Exelon Generation Company, LLC  
200 Exelon Way  
KSA3-N  
Kennett Square, PA 19348

Subject: Exelon Generation Company, LLC (EGC) Application for an Early Site Permit (ESP)  
Environmental Requests for Additional Information (TAC No. MC1125)

Re: U.S. NRC Letter to Exelon (*Requests for Additional Information (RAI) Regarding the Environmental Portion of the Early Site Permit (ESP) Application for the Exelon Generation Company Site (TAC No. MC1125)*), dated May 11, 2004

Responses to Environmental RAIs

Figure 4.5-1, Protected Area TLD Locations

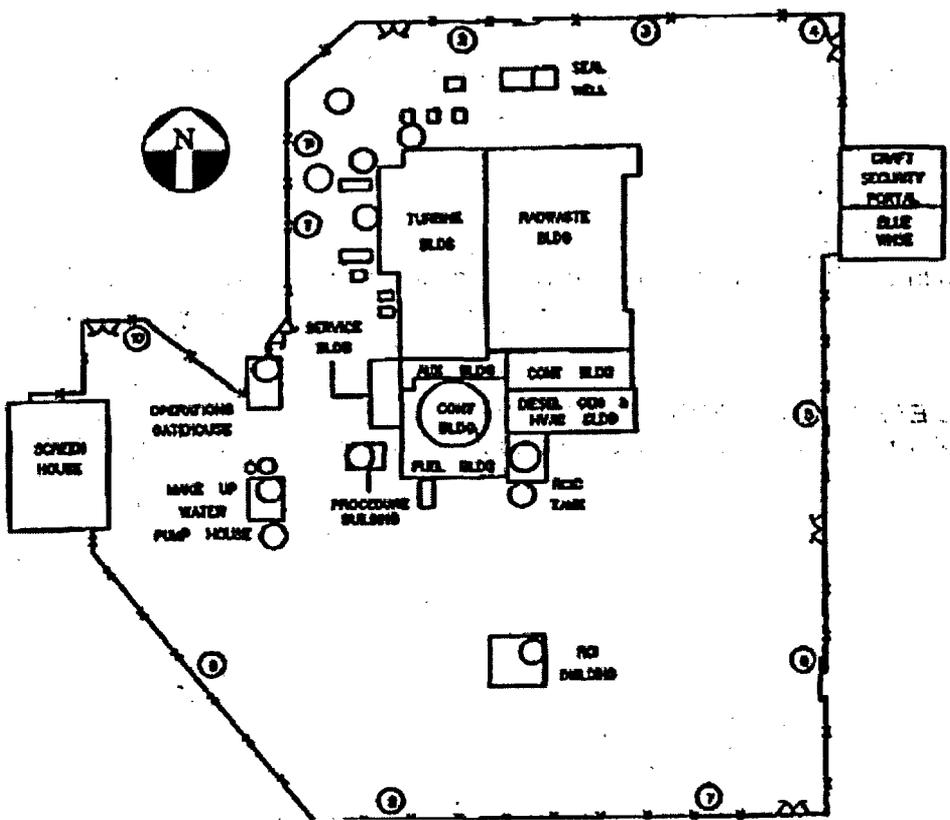
Item [4] Exelon should clarify Section 4.5.3.2 of the ER regarding type of perimeter readings.

**E4.5-1** In Section 4.5.3.2 of the EGC ESP application, Exelon states that "area TLD measurements during the third quarter of 2002 at the CPS protected area fenceline varied between 0.005 and 0.050 mrem/hr with an average fenceline dose rate of approximately 0.021 mrem/hr." Exelon used this value of 0.021 mrem/hr to derive the annual estimated dose per individual construction worker of less than 0.045 rem. As a result of discussions during the March 2004 site audit, Exelon stated that they were going to revise the method used to calculate the estimated annual construction worker dose. Exelon proposed to base this revised dose on the average of all of the fenceline TLD data for the time period between the second quarter 2001 through the first quarter 2003 (eight quarters of data). The data from all 16 fenceline TLDs would be included in this data.

ER, Chapter 4, Section 4.5.3.2, Direct Radiation Measurements, will be revised to clarify the text regarding Environmental Thermoluminescent Dosimeters (TLDs) used to measure the ambient gamma radiation levels at locations in and around the CPS.

Table 4.5-1 provides a listing of quarterly TLD readings (net dose in mrem) for each of the 11 protected area fence line TLDs for each of the calendar quarters between the second quarter 2001 through the first quarter 2003 (eight quarters of data). The TLD fence line locations are shown on Figure 4.5-1. The average dose over this period considering the 11 TLD protected area fence line locations and correcting for average plant capacity factor is approximately 25 mrem.

Using the average dose rate of the 11 TLD fence line locations over this two year period is considered both reasonable and conservative for estimating the dose to the construction workers since this operating period is representative of the longer term operation of the CPS. Also when considering the construction of a future ESP plant at this site the majority of the time the construction workers will be located much farther from the CPS operating radiation sources than reflected in the fence line values. The principal source of radiation from CPS operation is the N-16 radiation emanating from the turbine building. As shown the highest dose rates occur opposite (west) the turbine building at TLD dose points 1 & 11 (Figure 4.5-1). Lowest values occur in the south-southeast direction (dose points 6, 7, & 8) in the direction of the ESP footprint (Power Block

Structure Area). The average dose rate at the protected area fence is estimated at 7.2 to 12.1 microrem/hr. The protected area fence line dose rates occur at distances of approximately 100 to 1000 ft from the CPS Turbine Building. The Exelon ESP facilities will be located more than 1000 ft from the CPS sources. Therefore the above listed average dose rates can be expected to be reduced to background. Skyshine studies for other BWR plants demonstrate that the dose rates may be reduced by a factor of 3 to 5 due the increased distance.

Add new Figure 4.5-1.
